## SUBMITTAL SUMMARY REPORT Waiver STA-000672-2026

<b>PLAN NAME:</b> Leighton Estates duplex	<b>LOCATION:</b> 0
<b>APPLICATION DATE:</b> 04/22/2026	<b>PARCEL:</b> 3570-012-004
<b>DESCRIPTION:</b> I would like to build a duplex on the referenced parcel, in order to do this I need 100' on the frontage width, which I do not. I have 80', and so, I was told by the development review board on Thursday to send in this request. I should mention that the surrounding parcels, similar in size, built duplexes in the last year. LDC 4.2.11.C

RE: Water Service Availability – Parcel # 3570-012-004

# 97TH ST. DUPLEX OCALA, FL

## SITE PLAN

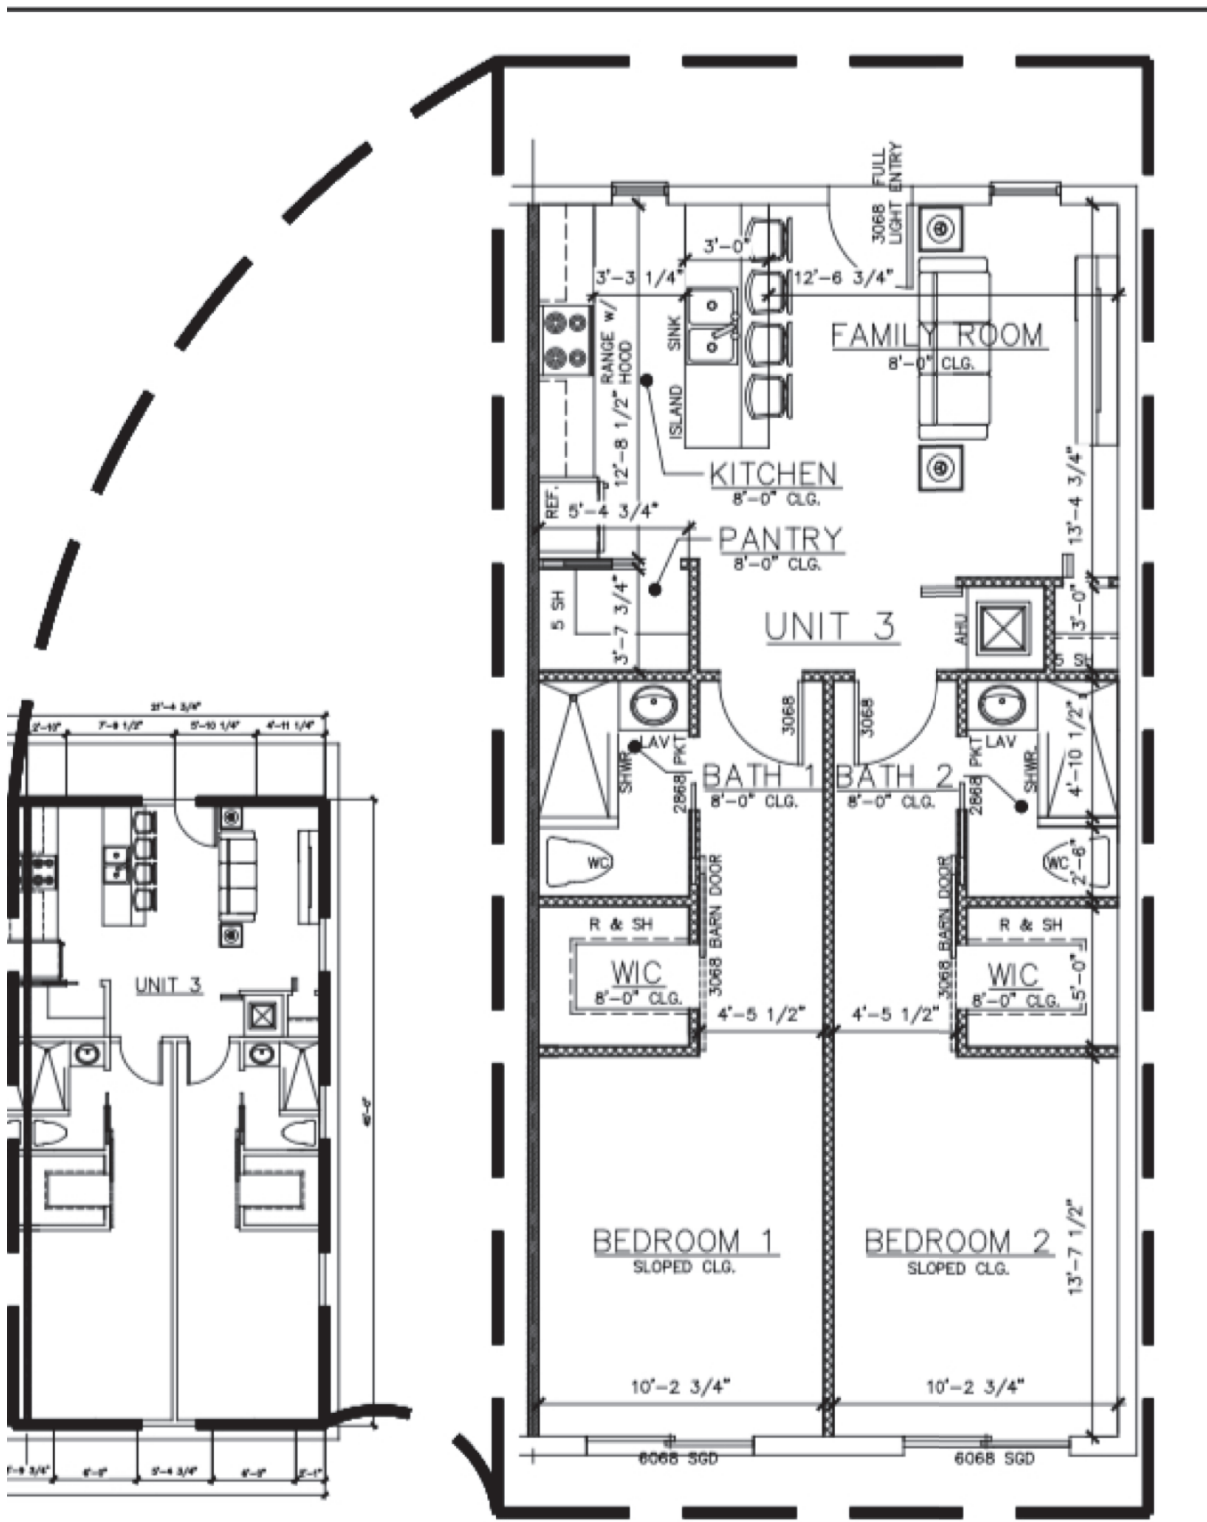
OCE Stormwater (Permits & Plans) (Office of the County Engineer)	Alexander Turnipseed	05/05/2026	04/27/2026	Informational
<i>Comments</i>	Approved. The applicant owns a 0.26 -acre parcel (3570-012-004) and according to the MCPA, there is approximately 680 sf existing impervious area on-site. The applicant is proposing to remove the existing impervious area and add 3,868 sf for a duplex. The total existing and proposed impervious area is 3,868 sf. The site will be approximately 95 sf under the allowed 35% (3,963 sf) per the Marion County LDC. There is no FEMA Special Flood Hazard Areas or Flood Prone Areas on the property. Based on the note on the site plan, the applicant appears to have applied for a waiver under the assumption the lot was 0.25-acres rather than 0.26-acres, which would have set the property over the allowable impervious area.				
	OCE Survey (Plans) (Office of the County Engineer)	Theresa Smail	05/05/2026	05/04/2026	Not Required
